# CITY OF PORTLAND, MAINE

Project Name:	Ten Unit Townhouses	Project ID:	2016-099
Address:	70 Anderson Street	CBL:	023 B021001
Applicant:	Redfern Properties, LLC		
Planner:	Shukria Wiar

# PLANNING BOARD REPORT PORTLAND, MAINE

Ten Unit Townhouses  
70 Anderson Street  
Level III Subdivision and Site Plan Review  
2016-099  
Redfern Properties, LLC, Applicant

Figure 3: 70 Anderson Street Site Plan

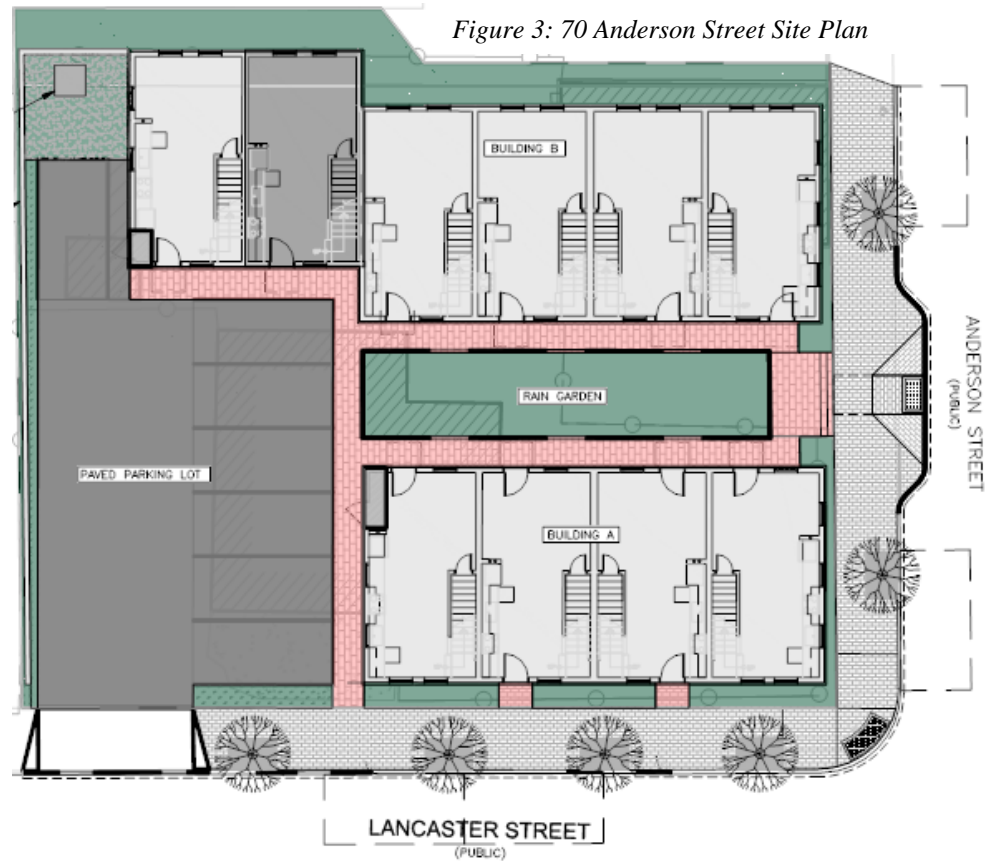
Tenant parking is to be provided on-site with a driveway access from East Lancaster Street. There will be seven surface parking spaces as part of the project. New brick sidewalks and street trees are proposed on Anderson and E. Lancaster Streets. The development is also proposed with landscaping between the building and proposing a green wall on both frontages.

The site will be accessed by an existing curb cut on E. Lancaster Street. The circulation for the site will consist of vehicles pulling in and backing out onto E. Lancaster Street. After reviewing the site plan, there may be opportunity for the first three parking spaces along the street, to maneuver so they can pull out of the parking lot instead of backing out. Tom Errico, P.E. Ty Lin reviewed this detail and also reviewed the proposal's details including the access, parking, and vehicle circulation (Attachment 1). The proposed project is not anticipated to cause unreasonable traffic congestion. Mr. Errico finds the project to be acceptable and states:

The surface parking lot will have a twenty foot (20’) parking aisle width that does not meet standard of twenty-four feet (24’); therefore the applicant has requested a waiver of this standard. An auto-turn analysis has been provided documenting adequate vehicle circulation and the information has been reviewed by the City’s traffic engineer, who states that *“the applicant has provided an Auto-turn analysis and I support a waiver from City standards given site characteristics”*.
